Subject: [FIXED] Beam pipe valves?

1) [viewer.gif](#), downloaded 1088 times

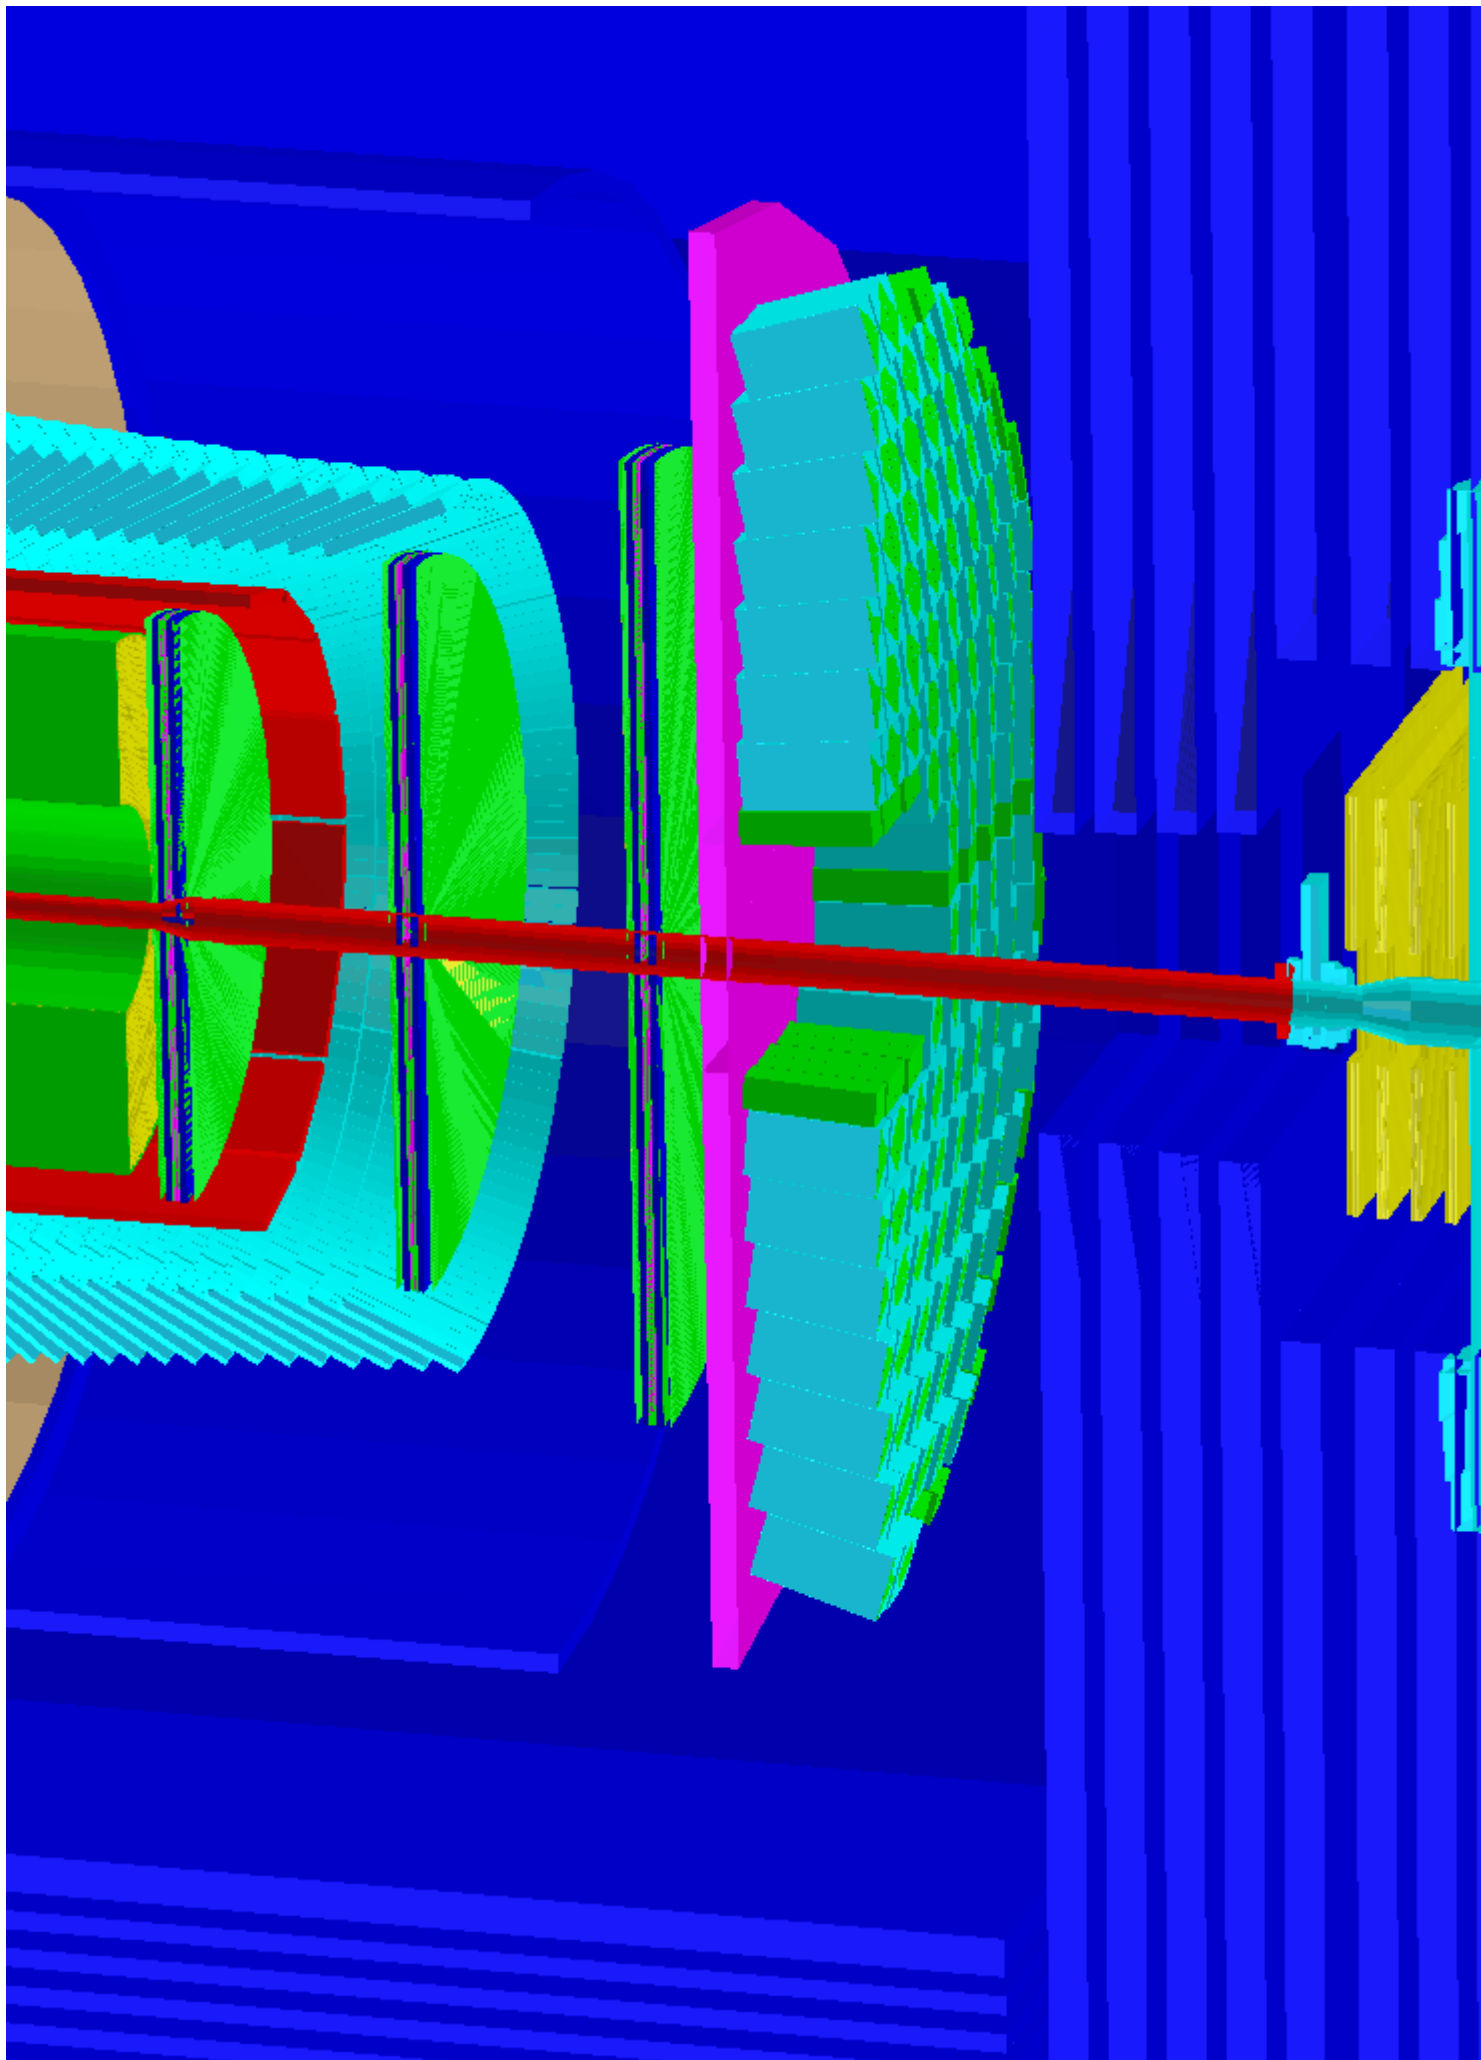
In the OGL drawing you can see that the pipe has a sort of "tower" which is in the middle of the muon filter. I am wondering what is wrong there, if the "tower" should be really there, if maybe the muon filter should be modified to host it, or if maybe we have some geometry problems.

Indeed, this is the first pumping station downstream of the target. The description corresponds to what is to be found on EDMS since several years. So I guess that muon description is not up to date?

Fixed!
